7/22/92	ADDENDUM 1 - GENERAL REVISION
DATE	REVISION
STATE OF HAWAII DEPARTMENT OF TRANSPORTATION HIGHWAYS DIVISION	
SITE PLAN	
HAIKU O&M FACILITY	
INTERSTATE ROUTE H-3	
F.A.I. PROJ. NO. I-H3-1 (66)	
SCALE: 1" = 20'	DATE: JUN 1992
SHEET NO. PBI OF 28 SHEETS

HAIKU O & M FACILITY
INTERSTATE ROUTE H-3
F.A.I. PROJ. NO. I-H3-1 (66)

7/21/92	ADDENDUM I - DELETED KEYED NOTE 28
DATE	REVISION

1/22/92	APPENDUM 1 - REVISED ROOF OPENINGS FOR EXHAUST FANS AND DUCTS
DATE	REVISION
STATE OF HAWAII DEPARTMENT OF TRANSPORTATION HIGHWAYS DIVISION ARCHITECTURAL ROOF PLAN - 1B HAIKU O & M FACILITY INTERSTATE ROUTE H-3 F.A.I. PROJ. NO. I-H3-1 (66)	
SCALE: 1/8" = 1'-0"	DATE: JUN 1992
SHEET NO. PB5 OF 28 SHEETS

MECHANICAL PLUMBING PLAN
& RISER DIAGRAMS

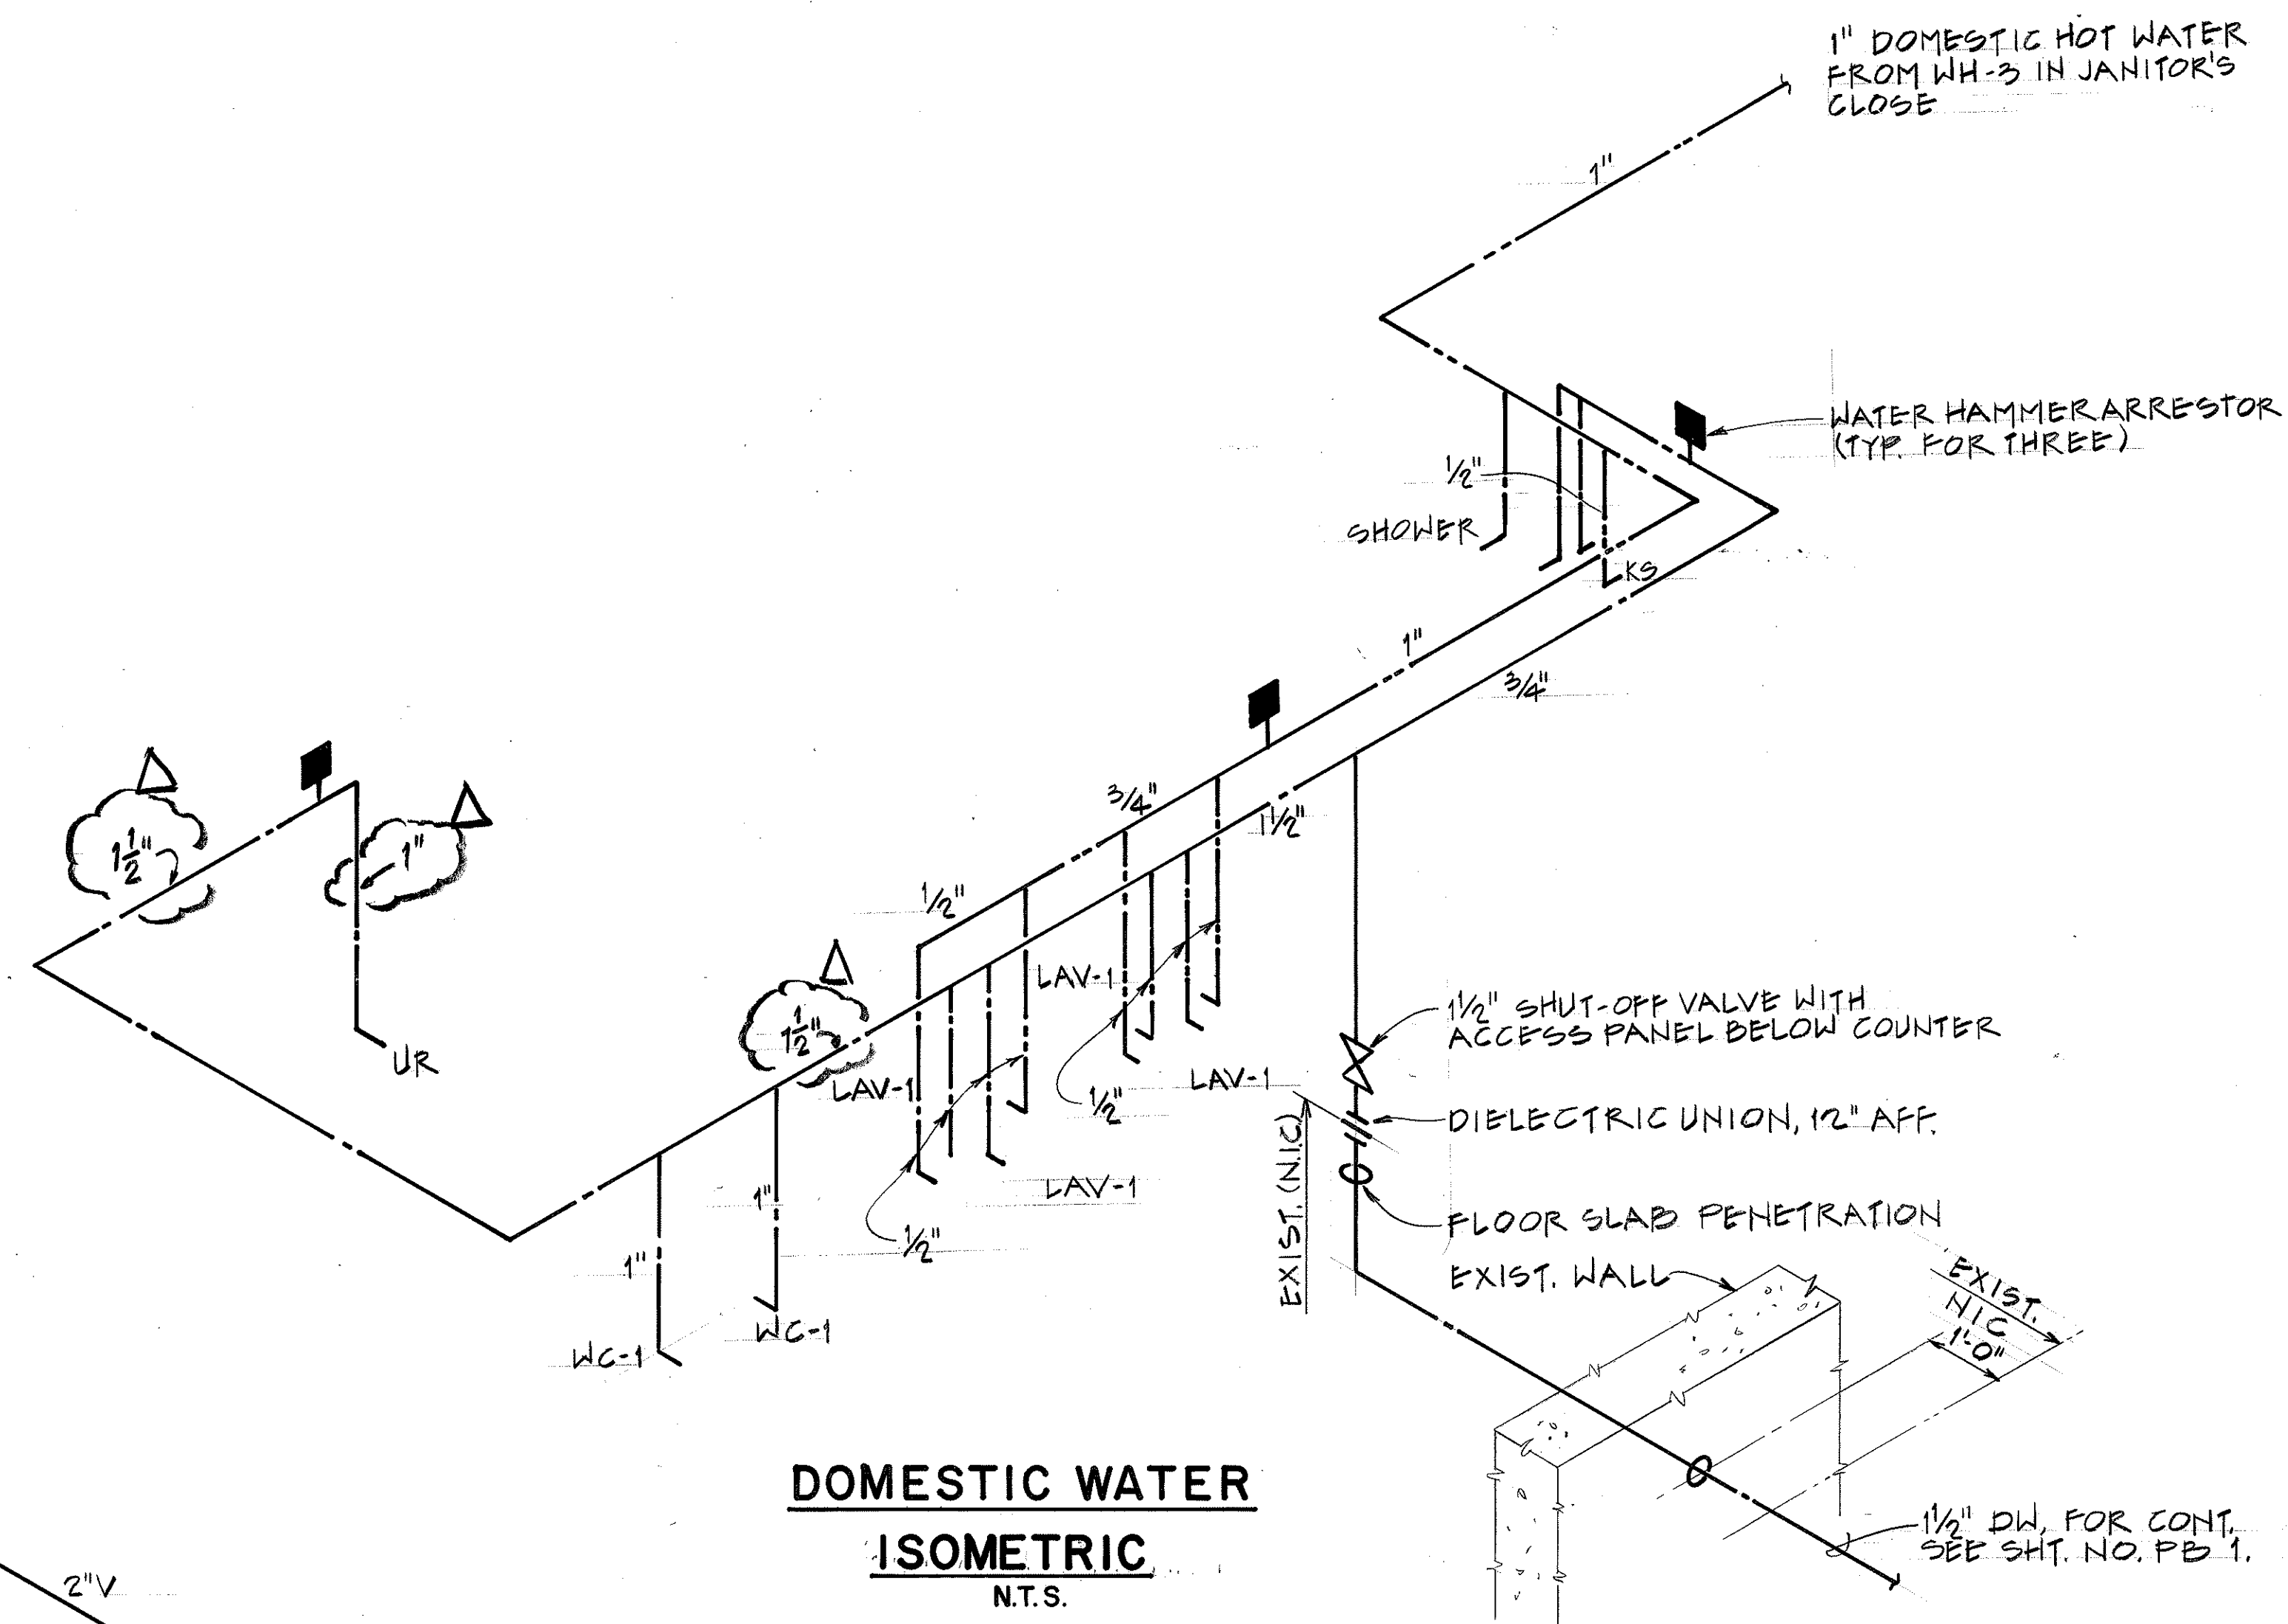
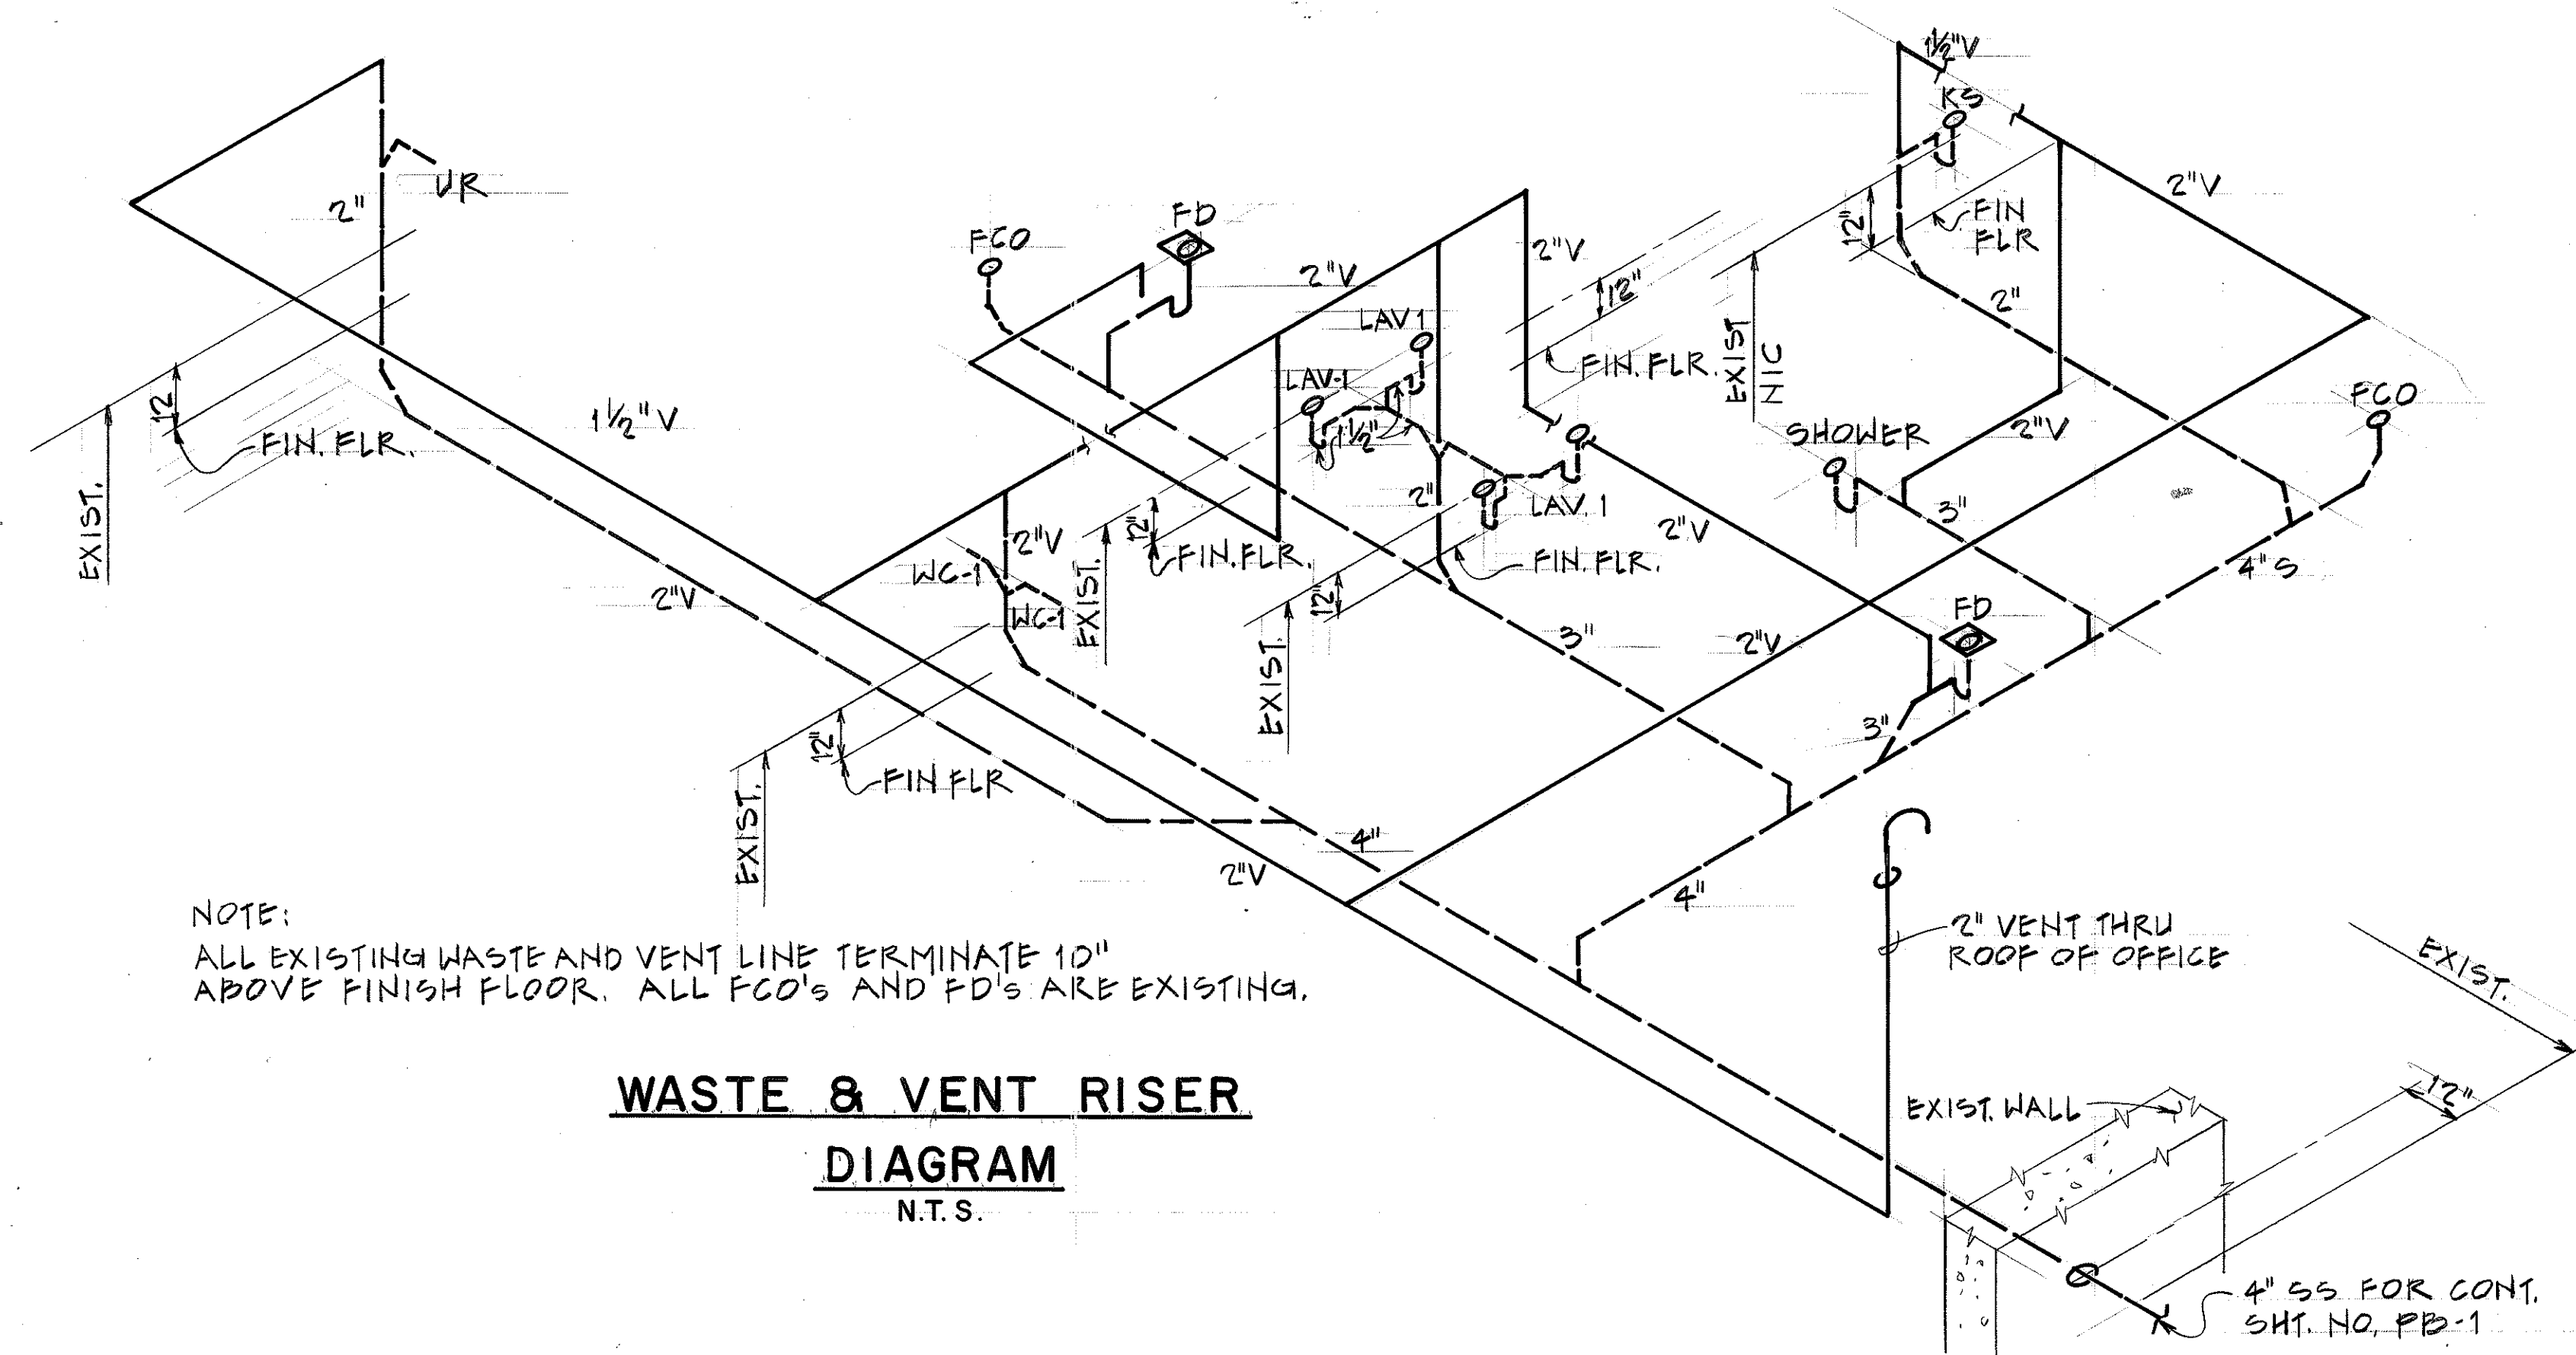
3/1/95	REV. PER DCN 66-062
7/22/92	ADDENDUM-1 ADDED RISER DIAGRAMS
DATE	REVISION
